Agenda Item 3
1150 Highland Avenue
New Residence

Staff Report
Excerpt of April Meeting Minutes
Building Scale Summary
Vicinity Map
Air Photos

1150 Highland Avenue

Amberley Woods Courtyard Homes - Revisions to Previously Approved Plans

STAFF RECOMMENDED PLAN

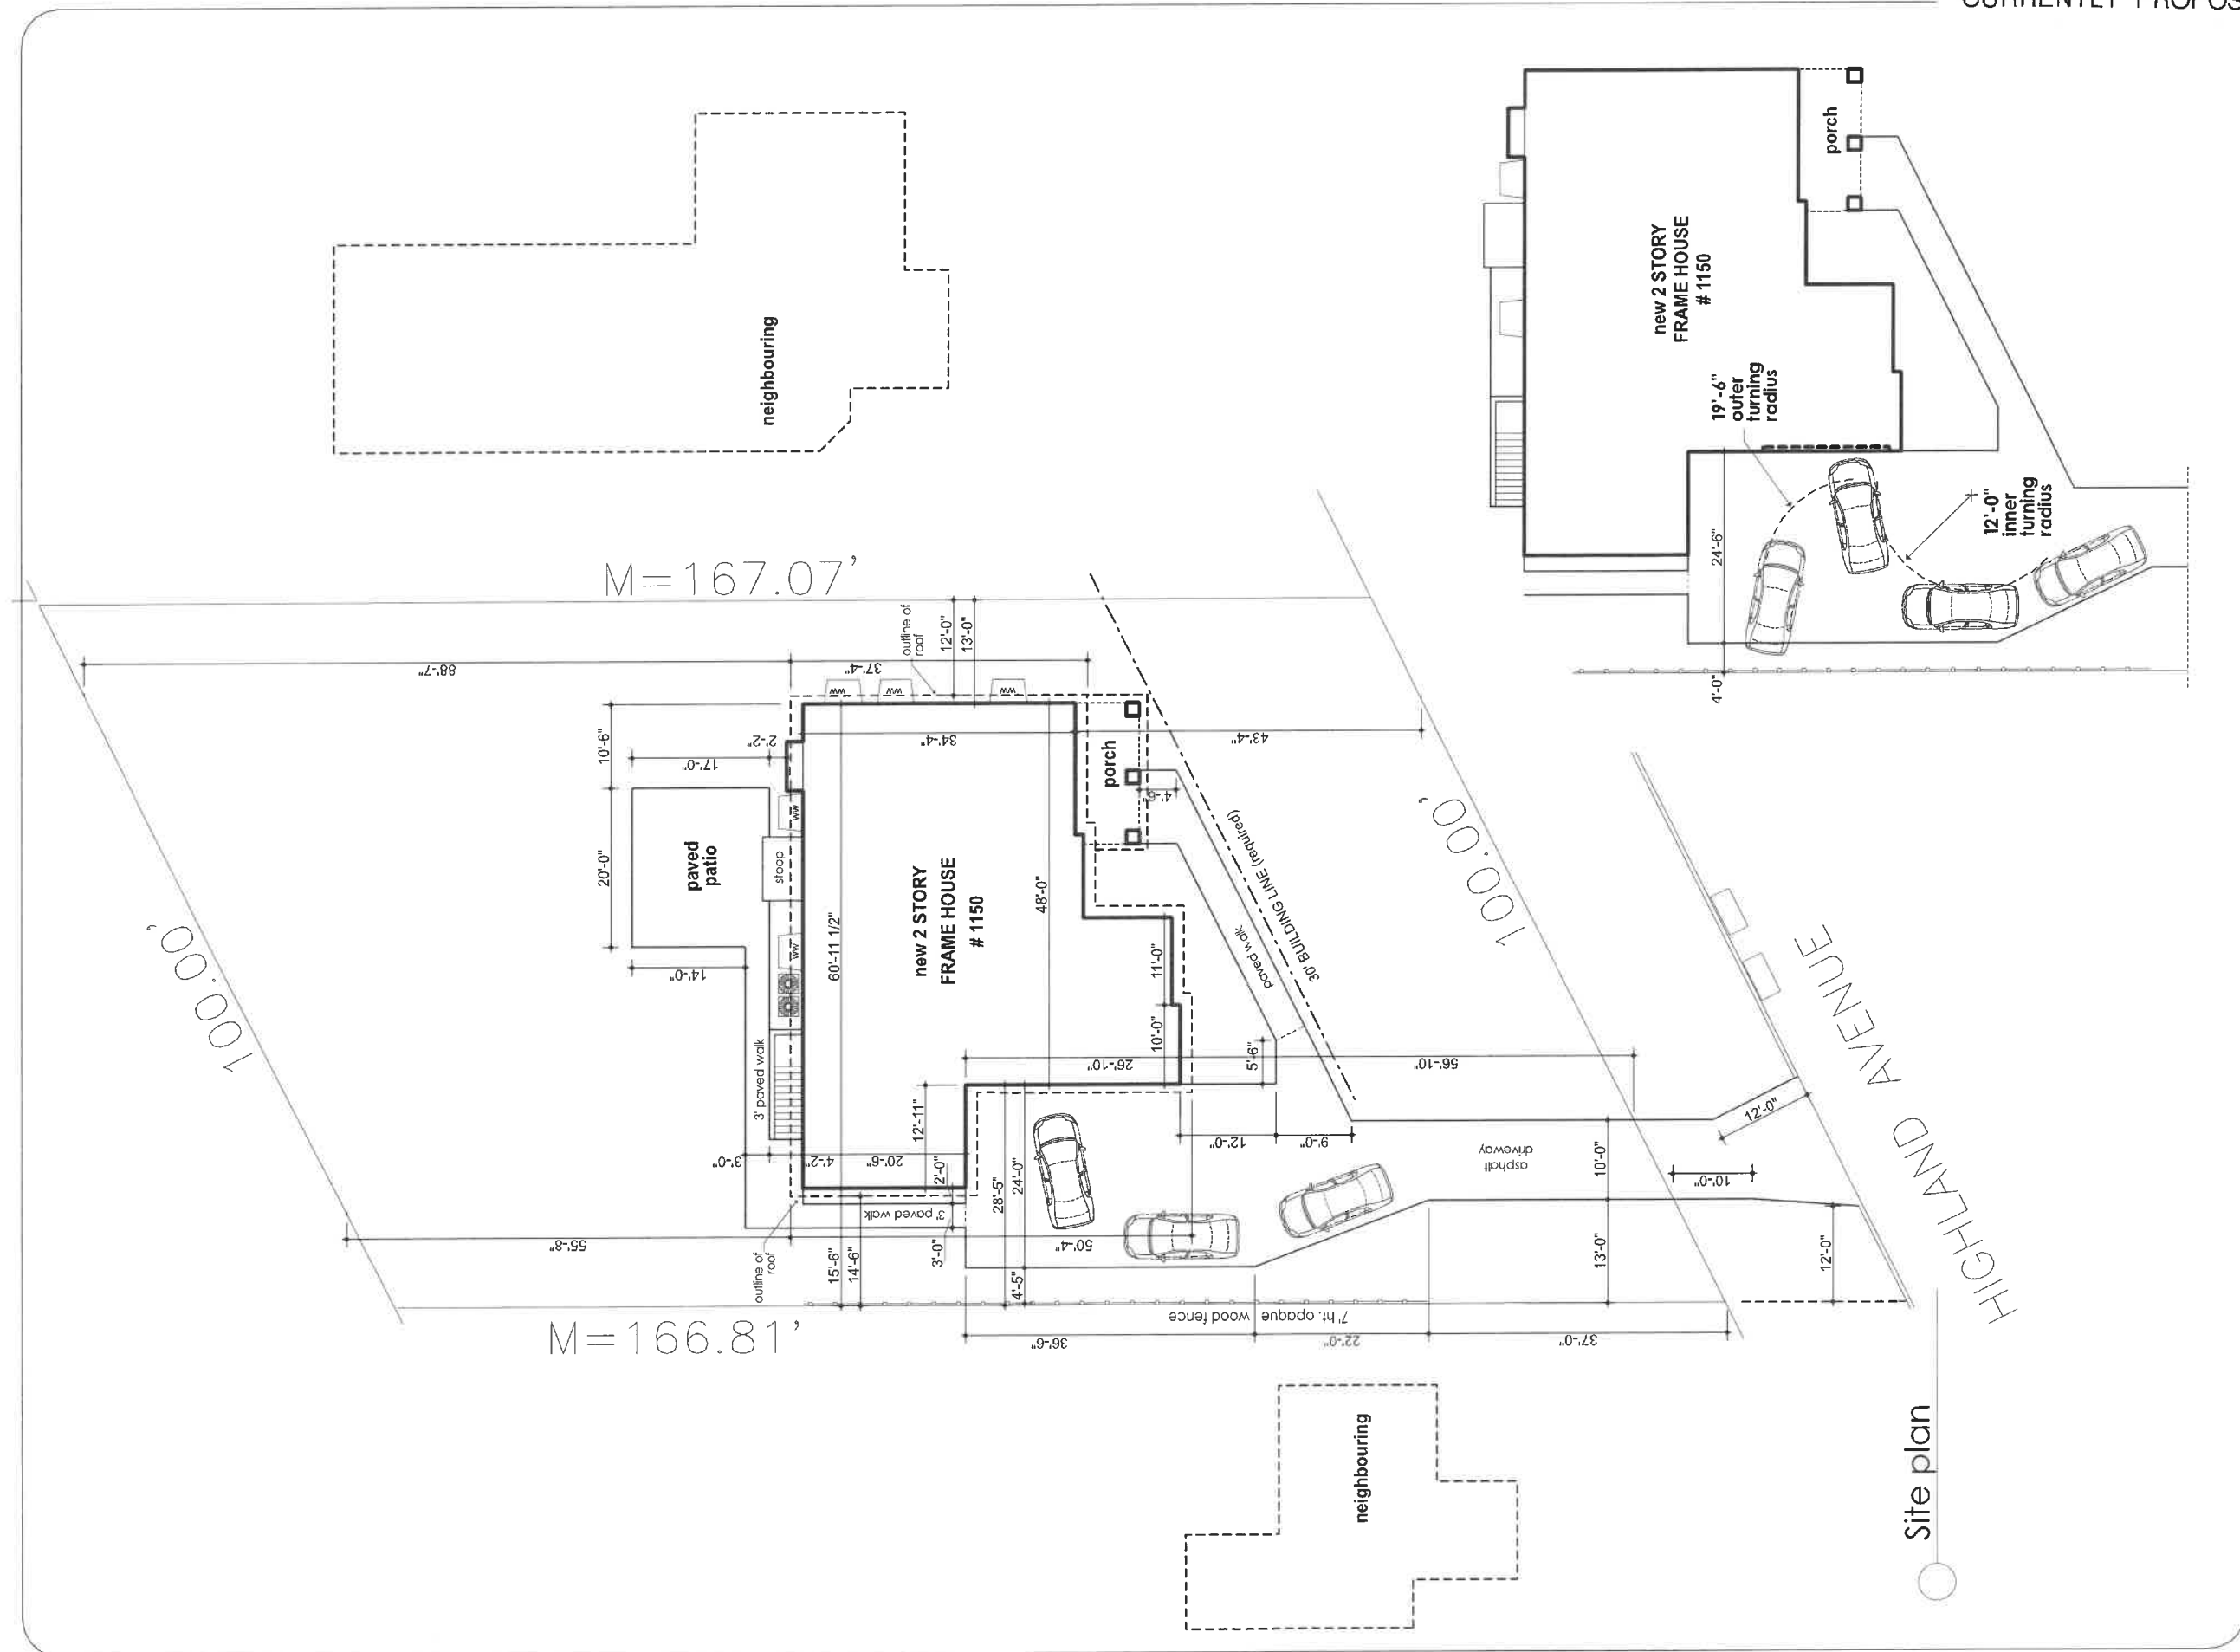
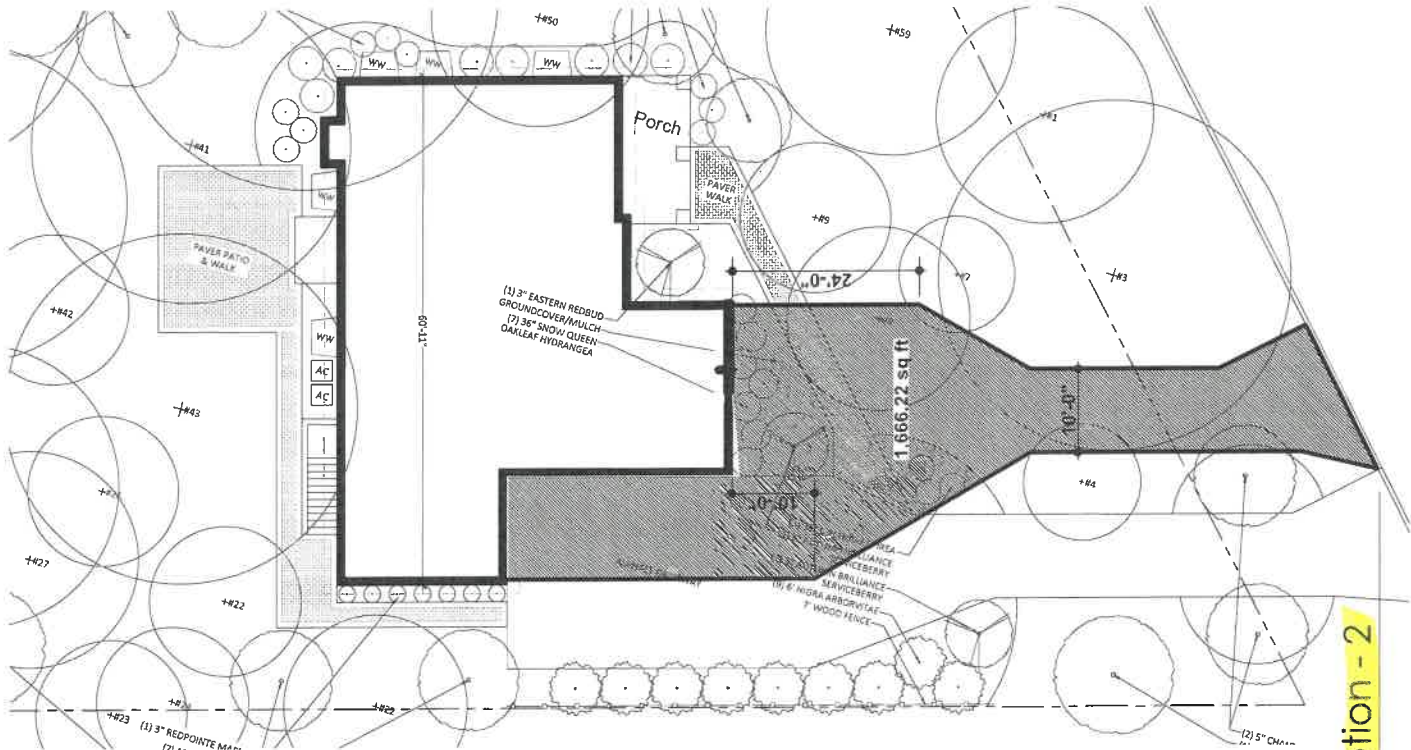
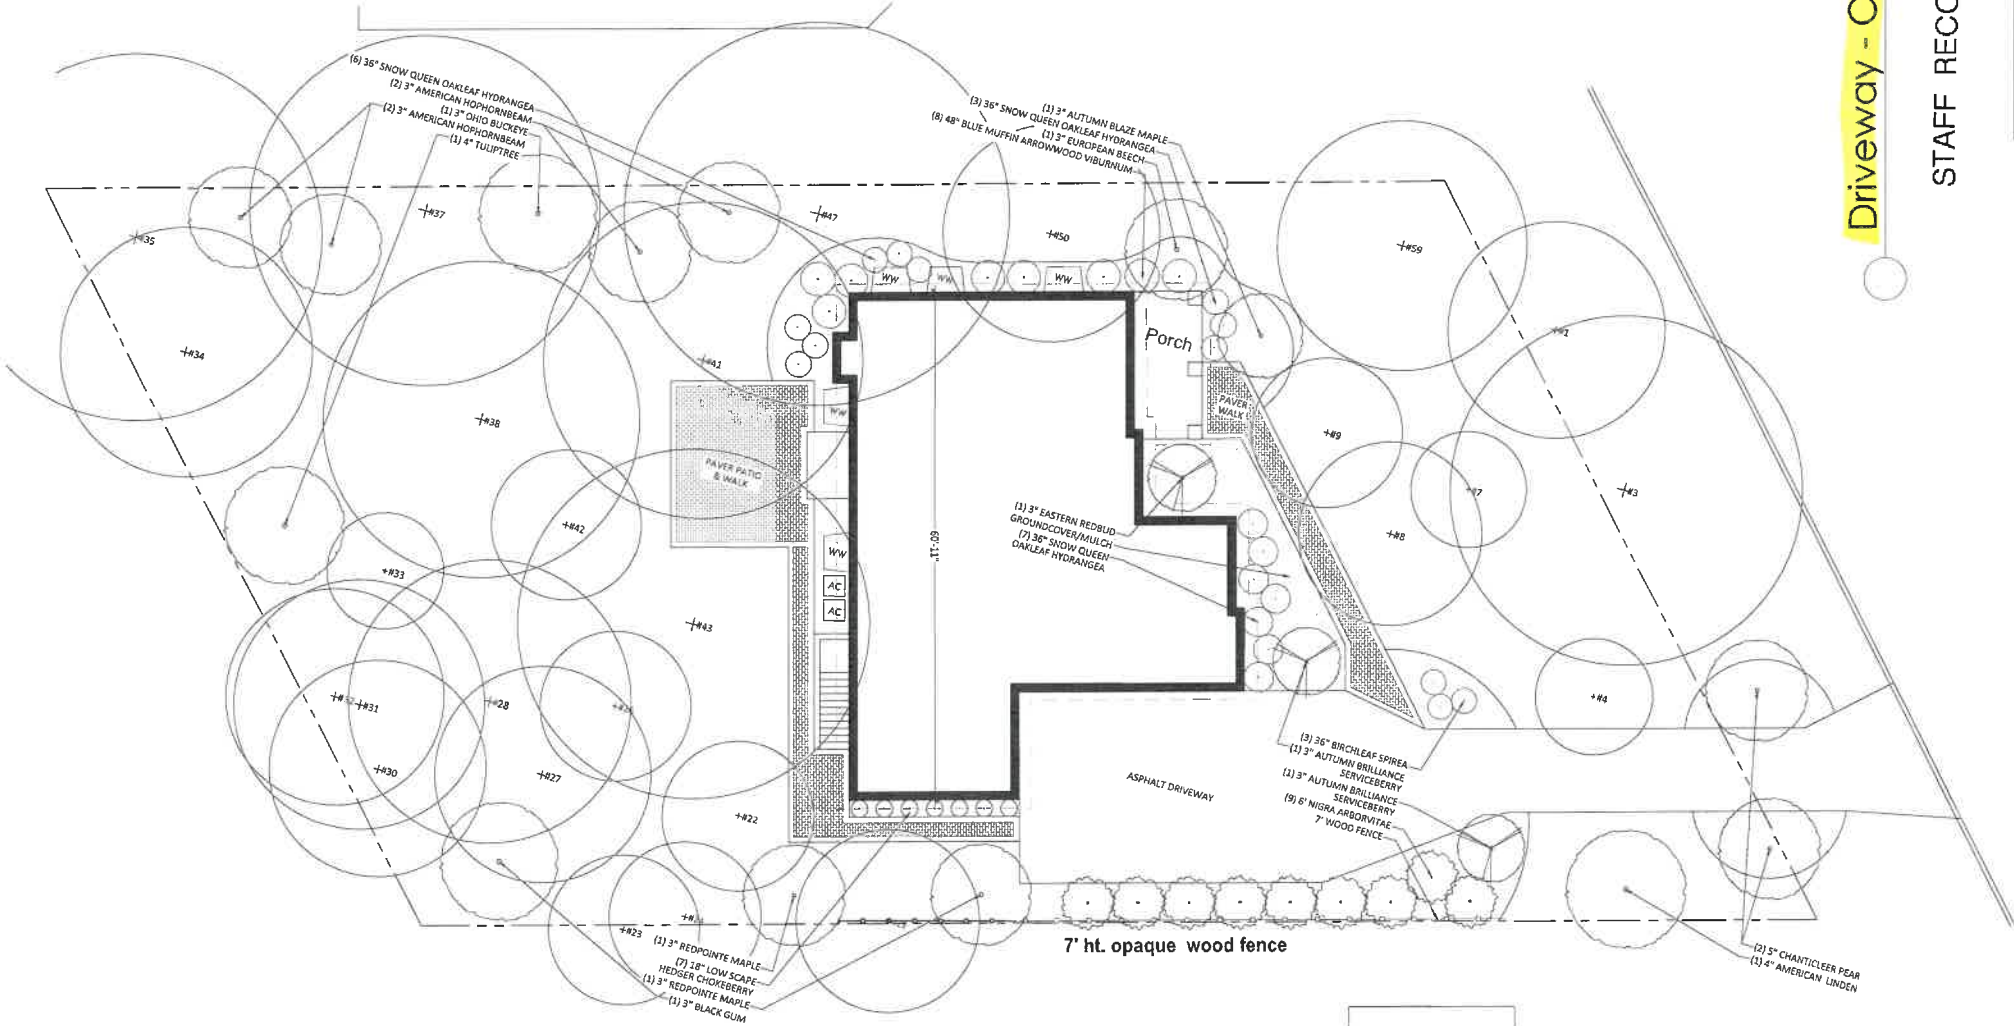
During the April meeting, the Board questioned whether the driveway as proposed was functional, whether there was adequate space for vehicles to back out of the driveway without encroaching on the limited space between the driveway and the property line.

Although an auto-turn study from an engineer was not provided, the petitioner's architect indicated vehicle movement on the revised site plan included in the Board's packet. There are discrepancies

between the width of the driveway as shown on the proposed various plans in the packet. The site plan shows the width of the driveway as 24 feet, and plan with the vehicles indicated shows the width of the driveway as 24 feet and 6 inches. The material submitted does not appear to include enough information to determine whether the driveway for the side load garage is functional. It is important that the driveway be adequately sized given the limited space on the south side of the home otherwise, it is likely that future homeowners may want to extend the hardscape surface all the way to the property line.

- Staff recommends the alternate plan, with the front load two-car garage for functionality and to minimize impacts to the neighboring property to the south by providing space for drainage and landscaping. The alternate plan more closely aligns with the garage and driveway locations in the surrounding neighborhood.

- a. The site plan, driveway configuration and design of the home as reflected in the alternate plan provided to the Board.
2. The stone shall be a minimum of 4 inches in depth.

PROPOSED SIDE (EAST) ELEVATION
BRUNSWICK TUDOR - 1865 AMBERLEY COURT
PROPOSED CHANGES HIGHLIGHTED

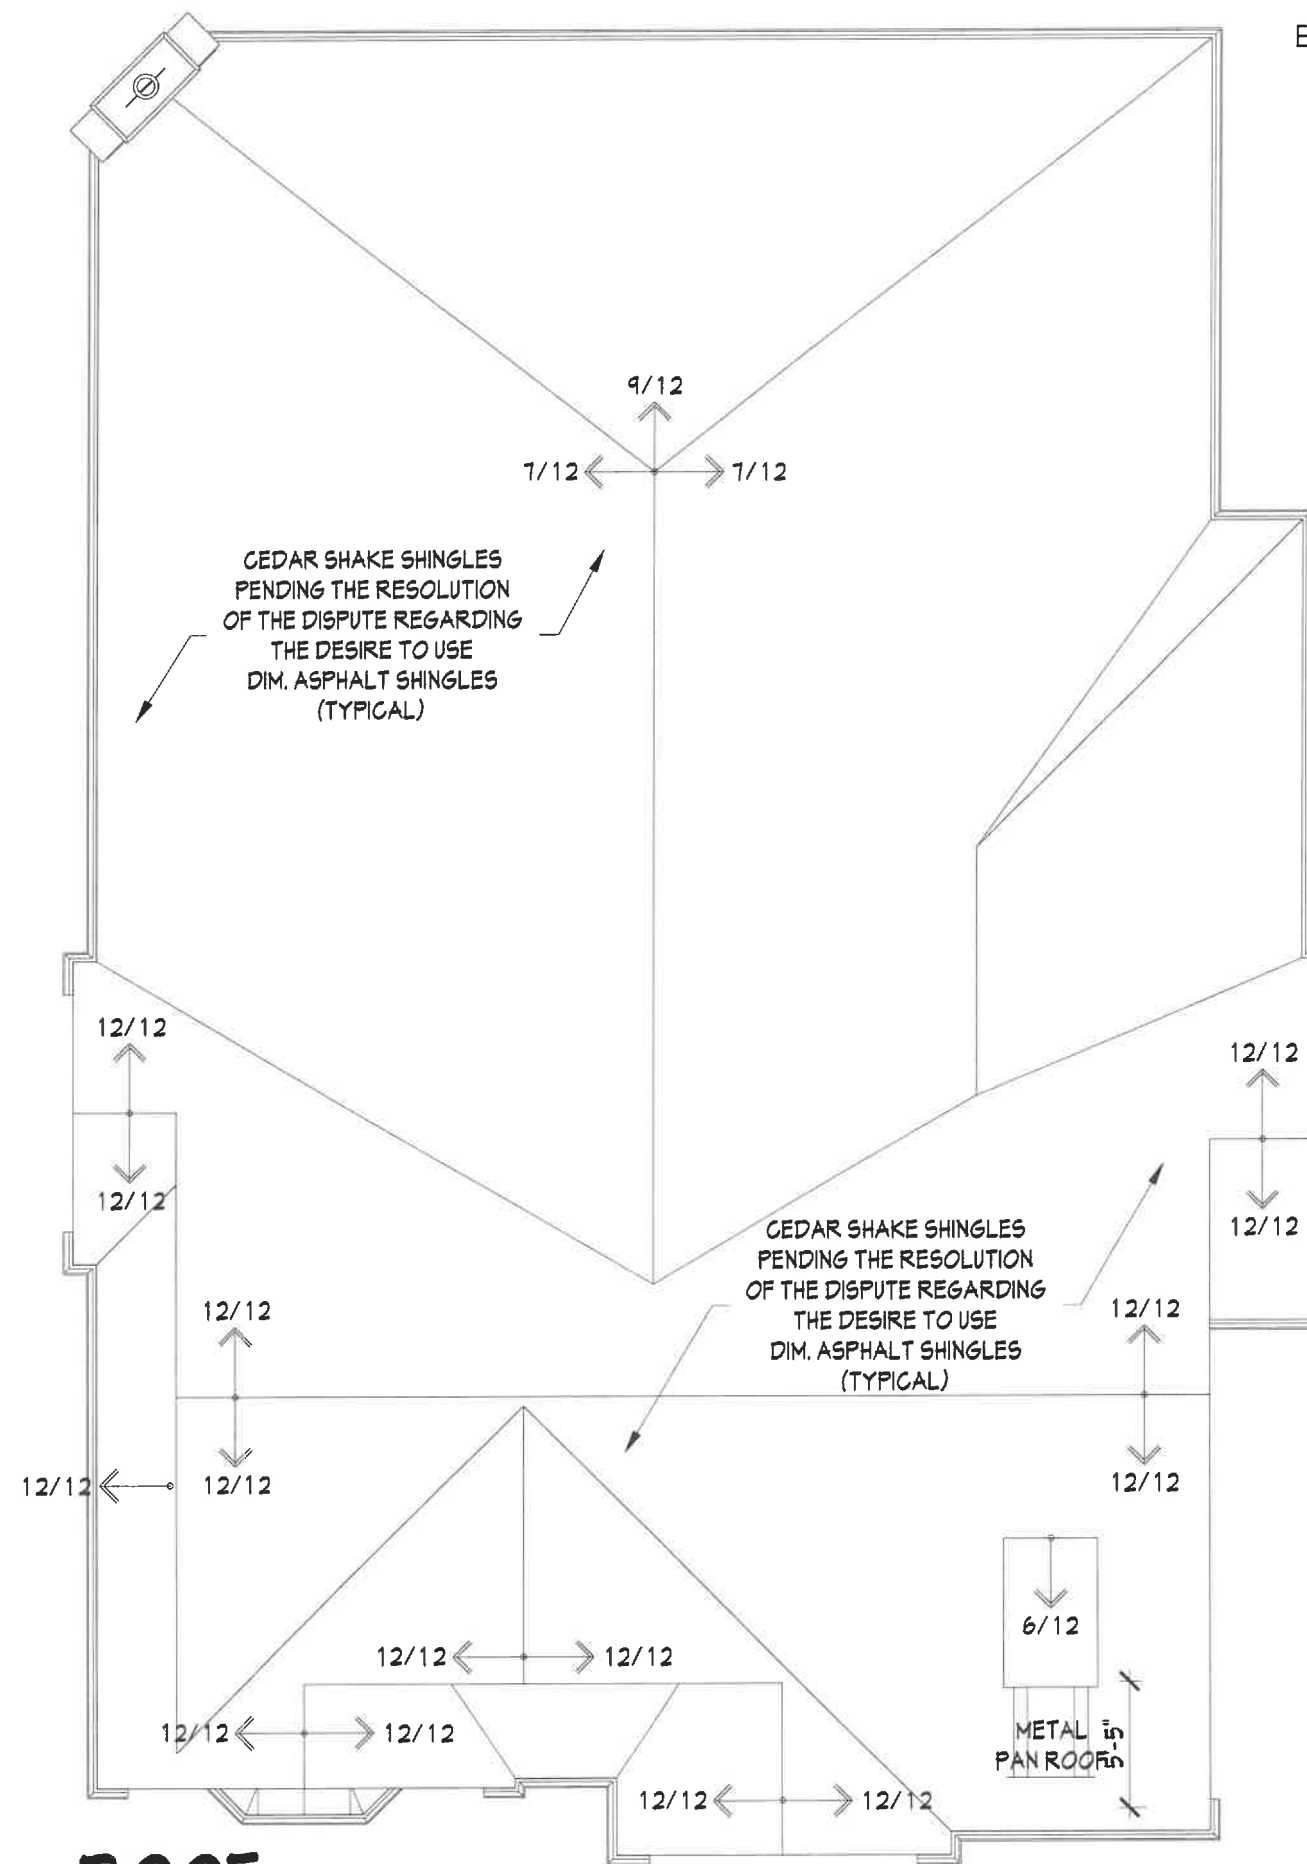
- The closed shutter detail was eliminated.
 - Staff recommends approval of this change **with modification** to the placement of the double casement window on the first floor. The previously approved closed shutter detail created balance with the window directly above. With the closed shutter detail removed, it is more apparent that the double casement windows on the first and second floors in this area are not aligned.

- The projecting bay on first floor was reduced in size.
 - Staff does **not** recommend approval of this change. The small size of the projecting bay presents an awkward appearance that stands out as an element that does not appear to be intentional or thoughtfully designed as it relates to the overall elevation.

- The placement of the double casement window on the east elevation shall be modified to create more of a balanced appearance with the window above.
- The size of the projecting bay on the east elevation shall remain as shown on the previously approved plans.
